Amendment No. 0001
05 September 2003

SUBJECT: Amendment No. 0001 to Specifications and Drawings for Construction of
Linton Mine and Mill Site Reclamation Project, Missoula County, MT.
Solicitation No. DACW45 03 B 0019.

ATTACHMENT: B
REPOSITORY AREA
TEST PIT LOCATIONS

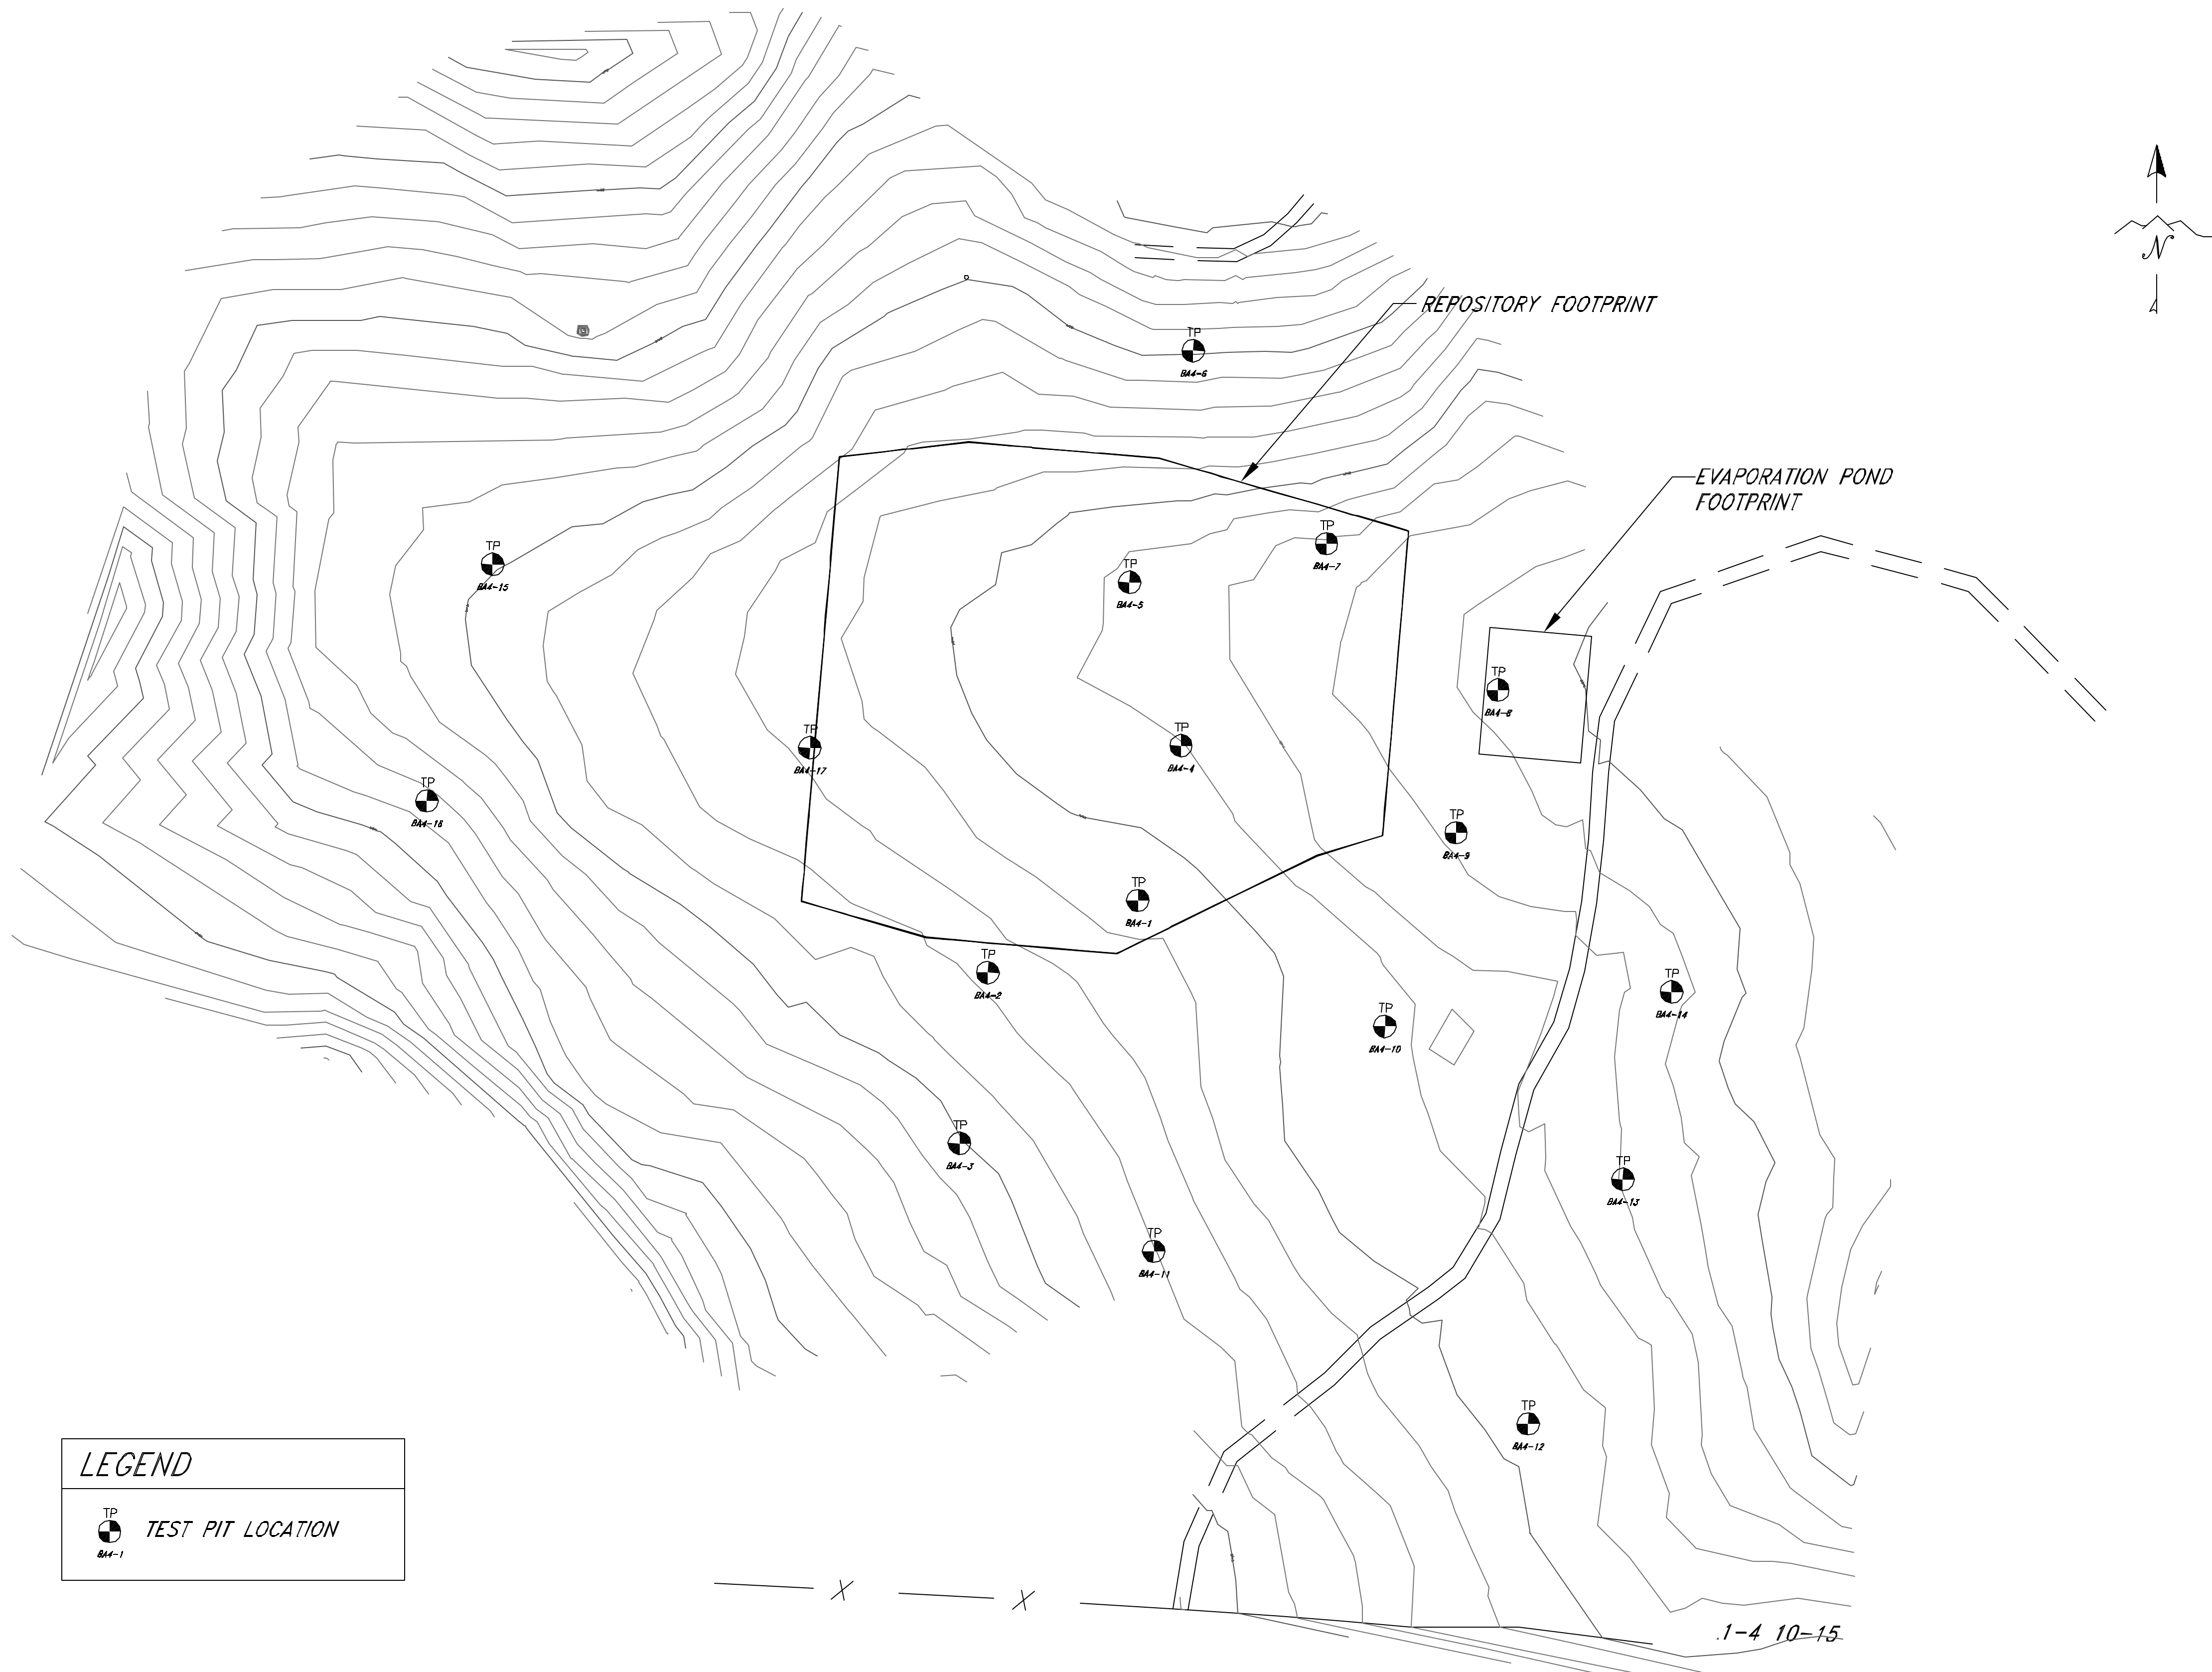
(3) Section 01010 Page 13 of 65, Paragraph 3.8.1,
a) 1st paragraph, after 3rd sentence add the following:
"Repository test pit soil data is provided for information only and attached to this section (See Attachment B)."
